# **Hemi Gold Project**

## **Environmental Review Document Assessment No. 2380**

### **COMMENTS FROM EPA SERVICES**

This document provides the comments from EPA Services regarding the revised Referral Supporting Document for the Hemi Gold Project proposed by De Grey Mining Ltd.

<small>Image Captured: 01 Jan 2024 - © Airbus 2025                  Created/Revised By: KMEL</small> <b>RPMGLOBAL</b>	<b>PROJECT</b>		<b>CLIENT</b>
	Hemi Gold Project - Referral Supporting Document		
	TRD2 and Moorambine Pools Observed In A Dry Condition		
	Figure 8-7	ADV-AU-00673

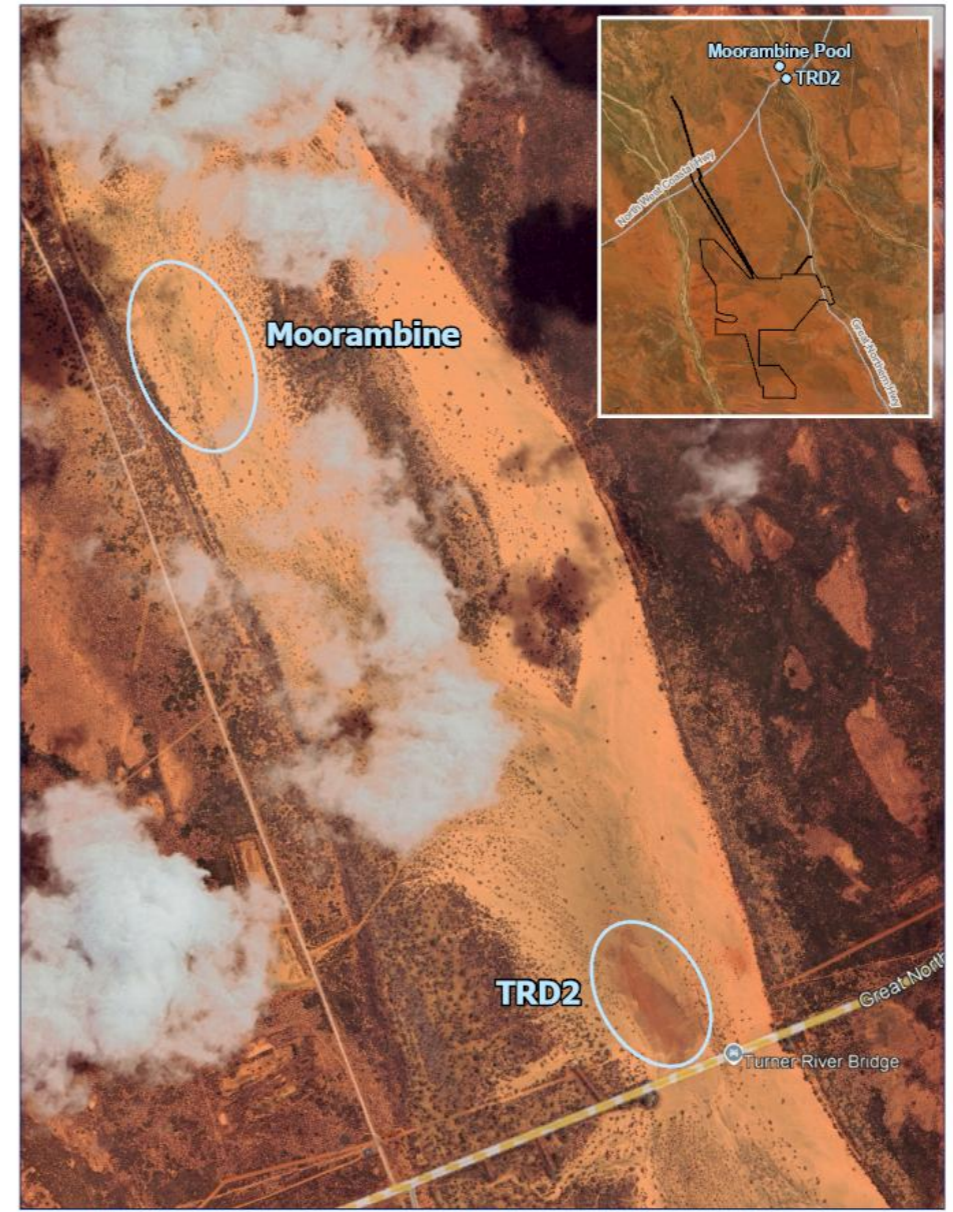
10.	<p>The survey effort downstream of the proposed discharge location in the Turner River is limited to a single pool (Appendix 11; Appendix 12). It is unclear how impacts to potential pools will be mitigated and managed if all pools have not been characterised.</p> <p>Further, Appendix 11 and 12 present photographs of pools containing water during both the wet and dry seasons. It is unclear why some of these pools (such as pools TR1 and TRD2) have not been characterised as permanent, when the presence of water appears to be year-round.</p>	<p>The baseline aquatic ecology study of the Turner and Yule River (Appendix 11) undertaken by Stantec was completed by suitably qualified Pilbara specialists.</p> <p>Sites were selected on the review of Satellite imagery and known (named) pools, with locations ground truthed in the field for accessibility and the presence of surface water. Subsequently, 10 sites were sampled during the dry season survey (November 2021); four sites within the Turner River (including one site in Turner River East) and six sites in the Yule River. During the wet season (May 2022), 12 sites were sampled; repeat sampling of 10 dry season sites with an additional two sites sampled (one each on the Turner and Yule Rivers).</p> <p>Reconnaissance of several additional sites along both the Turner and Yule River was also undertaken during the Study; however, these sites were dry during both the wet and dry season sampling and thus were excluded from the sampling program (i.e. pools did not form). A summary of the sites sampled, is provided in Stantec (2022) and reproduced below.</p>

To address the presence of water in some pools during both wet and dry seasons and ensure appropriate classification, De Grey undertook a precautionary review of aerial imagery. This assessment focused on TRD2, the only pool consistently sampled and located within the predicted wetting front of the surplus water discharge. The analysis confirmed that TRD2 experiences drying phases over time, supporting Stantec's classification as semi-permanent (refer to Section 8.3.4.2 of the RSD). The Figure below presents an example of TRD2 in a dry state.

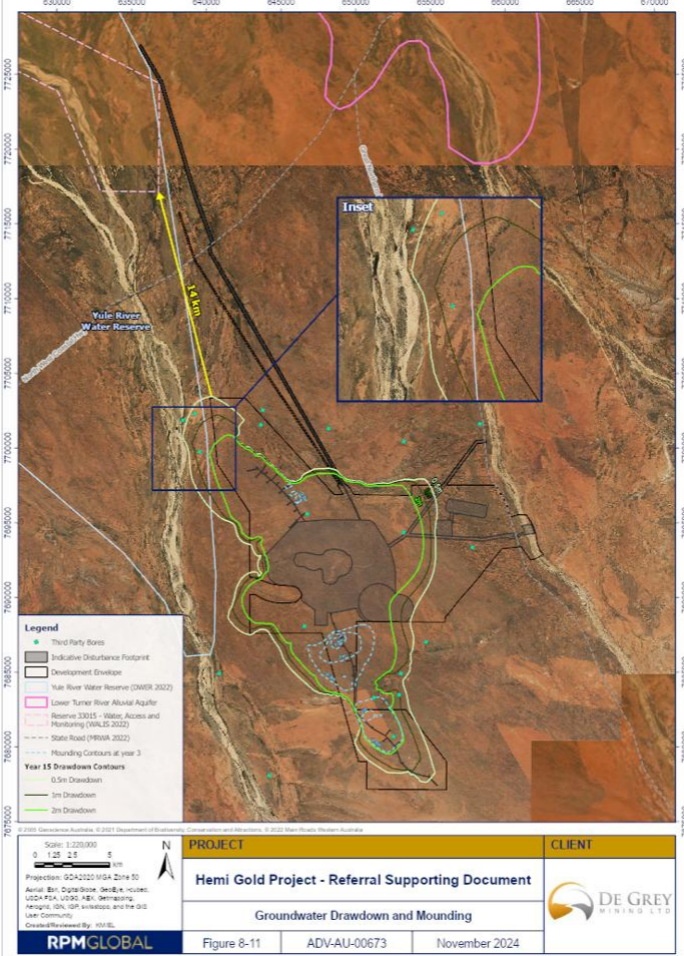
16.	ANON-G4BN-BAQ4-P	It is not clear where dewatering will draw groundwater from (i.e., alluvium, weathered rock) and therefore it is difficult to determine whether dewatering or post-closure drainage will reduce groundwater throughflow to the northwest, or whether the aquifer posed for dewatering underlies the Yule borefield.	<p>The hydrostratigraphy that has been developed from the mineral resource and groundwater bores installed to date is provided in Section 8.3.1 of the RSD (Figure 8-2) (reproduced below) and presented in Section 7.3.1 of Appendix 2. It shows the different aquifer zones based upon their fundamental lithological type and comprise from shallowest to deepest:</p> <ul style="list-style-type: none"> <li>• Upper Alluvium – laterally extensive aquifer system with low to moderate permeability and saturated thickness. The saturated extent includes the Yule, but not the Turner River.</li> <li>• Lower Alluvium (Palaeochannel) – basal palaeochannel sands and gravels with high permeability and storage values. This Palaeochannel is generally 1 km to 2 km wide and drains northwards towards the coast.</li> <li>• Saprolite Zone – uppermost sections of weathered bedrock with limited permeability.</li> <li>• Saprock Zone – lower section of weathered profile consisting of moderately to slightly weathered rock. Low to moderate fractured rock permeability in the igneous intrusives.</li> </ul>

Considering the hydrogeological cross-section presented in Figure 8-3 of the RSD (reproduced below), the following key aspects of Hemi's groundwater system are interpreted:

- Saprolite and saprock generally do not hold significant amounts of groundwater. This layer acts as a weak barrier to water flow (aquitard) and is unlikely to be a major water source during mining activities.
- Groundwater at Hemi is more likely to be found in fractured zones within igneous rock intrusions and near the contact zones between different rock types. These fractures provide pathways for water movement but have limited storage capacity. These fractures also become tighter and less permeable with depth.
- Bedrock permeability is very limited, likely becoming impermeable with no storage of water below approximately 150 m.

Based upon the above, most of the dewatering will occur in the upper and lower alluvium will minimal dewatering within the saprolite, saprock and bedrock profiles.
